Detailed Site Plan Glenwood Hills

DSP-21037-01

STAFF REPORT

SUBJECT: Detailed Site Plan DSP-21037-01
Type 2 Tree Conservation Plan TCP2-038-2023-01
Glenwood Hills

Figure 1: Detailed Site Plan

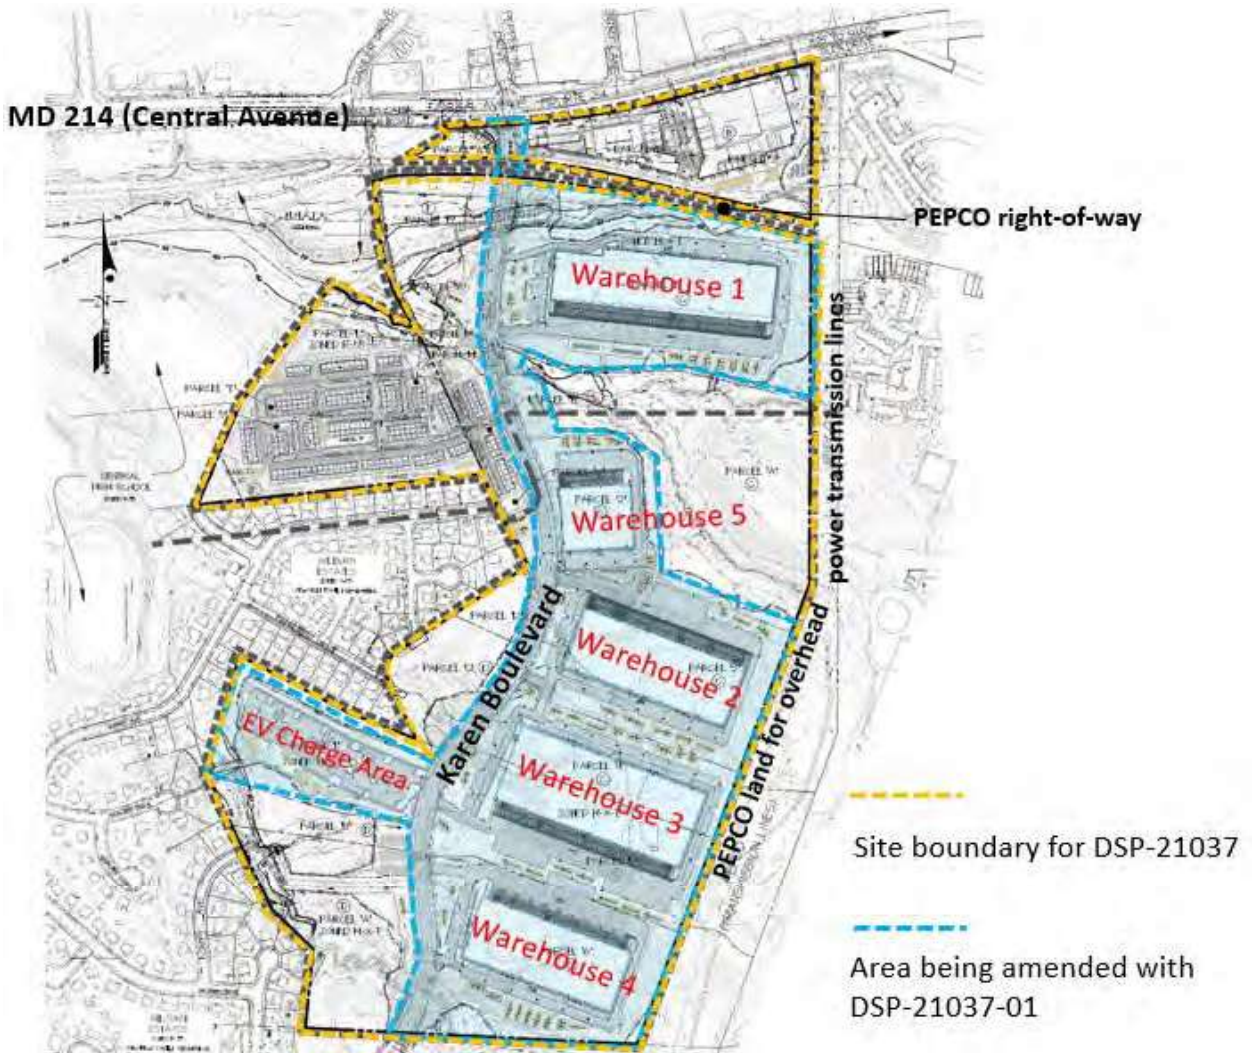
Note: *Conditions are included herein requiring the applicant to revise the total gross floor area (GFA) of the proposed warehouse/distribution buildings throughout the submittal, for consistency, and revise the GFA of the entire Glenwood Hills Development.

Note: *The size of the proposed loading spaces is 12 feet by 45 feet, which is conditioned herein to note such dimension on the plans.

Note: *Each bike rack only has a two-bike capacity. A condition is included herein requiring the applicant to revise the bike capacity expressed on the plans.

ELEVATIONS – WAREHOUSE 5

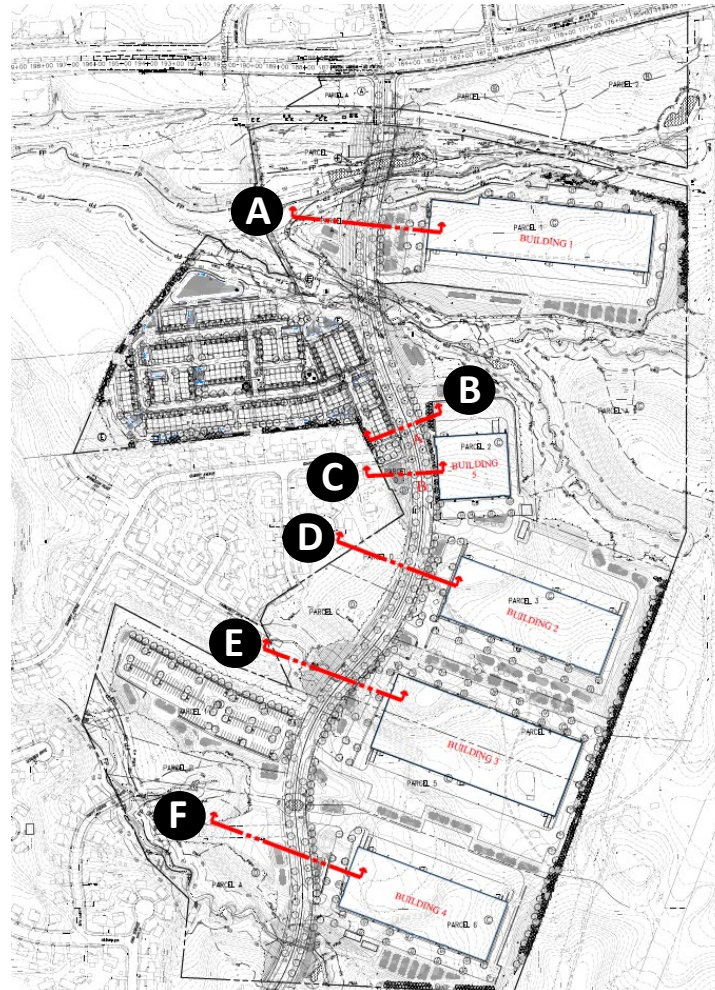
The subject DSP proposes five warehouse/distribution buildings with loading spaces, which are located internally to the subject property. With the planting along the Karen Boulevard frontage, and the 10- or 12-foot-tall screen walls, public view to these loading spaces is screened. A condition is included herein requiring the applicant to provide details of the screen walls. The submitted plans include a large-scale drawing of a trash enclosure designed with brick veneer, with an intent to match the proposed warehouse/distribution buildings. However, this brick veneer does not match the materials proposed for the warehouse/distribution buildings. The location of dumpsters is not shown on the plans. Conditions are included herein requiring the applicant to indicate the location of dumpsters on the plans, revise the large-scale plan to show trash enclosure materials compatible with the proposed buildings, and provide trash enclosure elevations with enclosure dimensions.
